TVA-WBN-TS-08-04

**WATTS BAR NUCLEAR PLANT (WBN) UNIT 1 - RESPONSE TO REQUEST FOR
ADDITIONAL INFORMATION RE: WATTS BAR EMERGENCY CORE COOLING SYSTEM
BORON REQUIREMENTS (TAC NO. MD9396)**

Response to NRC Request for Additional Information (Non-Proprietary)

Figure 1 - Boric Acid Solubility Limit

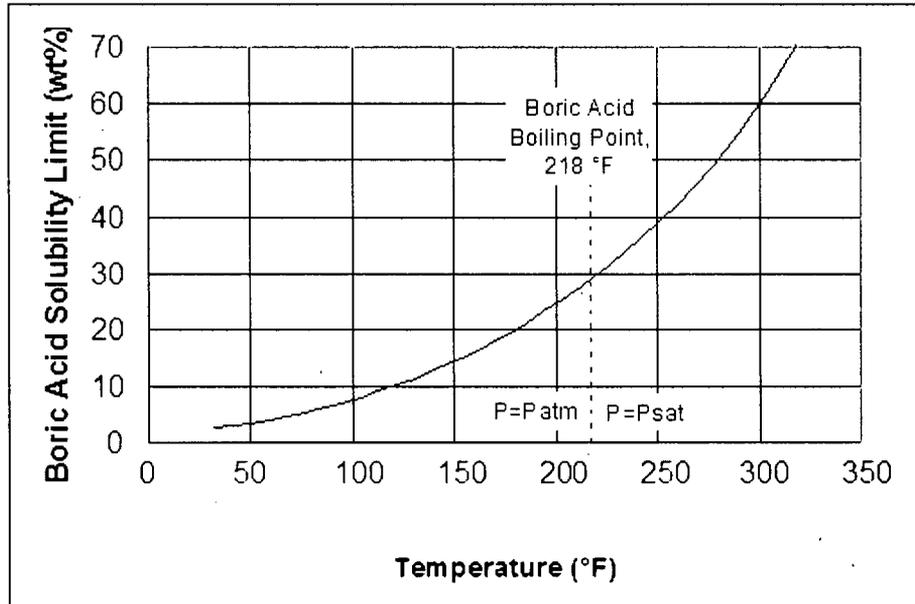
The NRC staff is aware that a boric acid concentration calculation has been performed that more closely aligns to the NRC staff's current expectations and acceptance criteria regarding the precipitability of boric acid in the long-term phase following a LOCA. Please provide a summary of this calculation.

- *The boric acid concentration limit is the experimentally determined boric acid solubility limit as reported in Reference 2 and summarized in Table 2 and Figure 1. For large breaks and large small breaks, the effect of containment or RCS pressure above atmospheric pressure is not credited and the boric acid solubility limit at 212°F is assumed. For large small breaks where RCS depressurization is not complete or for even smaller small breaks where the RCS might be at elevated pressures at hot leg switchover time, the solubility limit associated with the saturation temperature of water at the associated elevated pressure is credited.*
